AEC 17-178

Re: Review of Overburden Ground Water Levels, Melancthon Pit

Chart A – 2023-2024 Water Levels

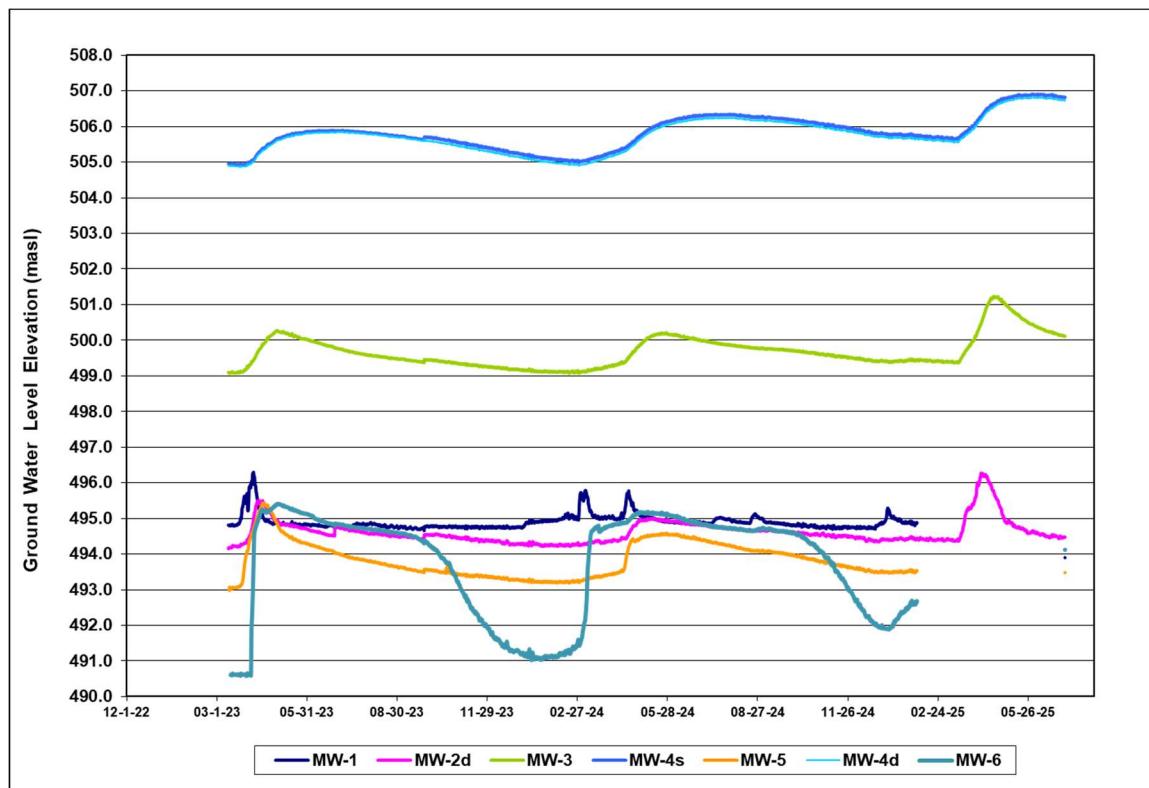
We understand that the Township's peer reviewer, WSP, had additional questions regarding the overburden ground water levels on the eastern side of the property, as the eastern side is the downgradient side. Part of the query also relates to whether MW-6 is at an adequate depth to provide a sentry function if there was a contaminant spill of Petroleum Hydrocarbons within the pit area.

After drilling on March 15, 2023, water levels in MW-6 did not start to respond until April 23, 2023, a period of approximately 40 days. This initial period is interpreted to be the period when the well annulus was gradually infilling, and took time because the silt unit has lower permeability. Seasonally, the water levels in MW-6 dropped to approximately 491masl (~1m above the base) during the 2024 summer and to approximately 492masl (~2m above the base) during 2024-2025 winter. The water levels since 2024 have remained above the base of the screened zone. The hydrographs are shown in the following chart.
